Re: **Docket No. 09-RENEW EO-01**, Comments of **Eagle Crest Energy Company** on Draft
Desert Renewable Energy Conservation Plan

Eagle Mountain Pumped Storage Project
 Eastern Riverside County, California

PROJECT BOUNDARY AND
 DRECP PREFERRED ALTERNATIVE

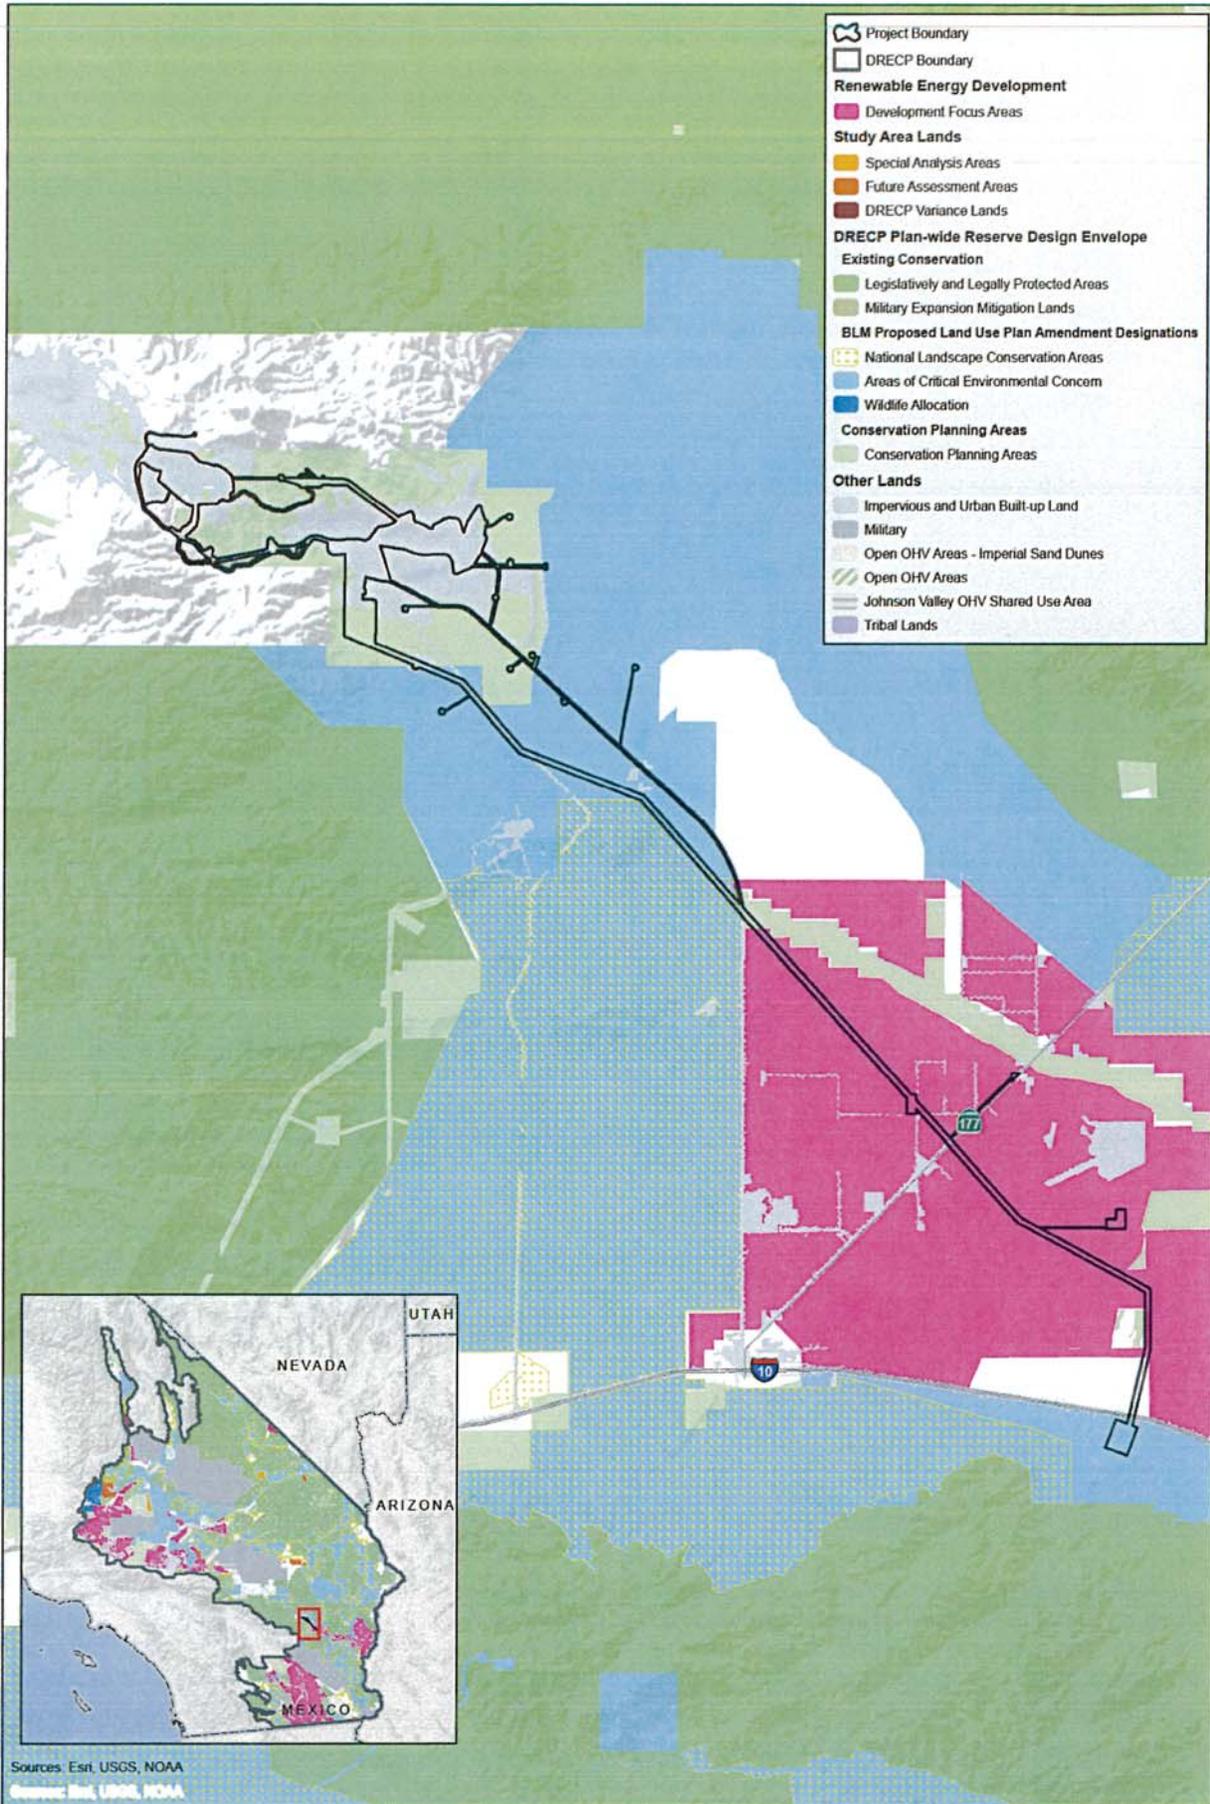
In our review of this complex planning document, it appears that there are several proposed landuse designations that would conflict with the Eagle Crest Project. *See* Exhibit A., Map. Exhibit A. illustrates the location of the Eagle Crest Project and the rights-of-way for the water and transmission lines approved in the FERC license and long-pending before the BLM, Palm Springs Field Office and California Desert District Office. *See infra*. It appears that BLM intends in the DRECP Preferred Alternative to designate portions of the Project rights-of-way as Areas of Critical Environmental Concern (“ACECs”) and National Landscape Conservation Areas. Each of those designations provides for heightened protections of federal land and limit uses on lands so designated. In addition, *central* areas of the Eagle Crest Project are proposed for inclusion in DRECP Conservation Planning Areas.² These proposed landuse allocations conflict with the FERC-licensed Eagle Crest Project and exceed BLM’s legal authority and they should not be included in the Record of Decision.

² The Exhibit A. Map also includes certain lands denoted in white that underlie the Project transmission and water lines. The color designation white is not included in the Map key. We are unclear what this designation might indicate, but again BLM lacks the authority to provide for landuse allocations that conflict with Federal Power Act purposes.
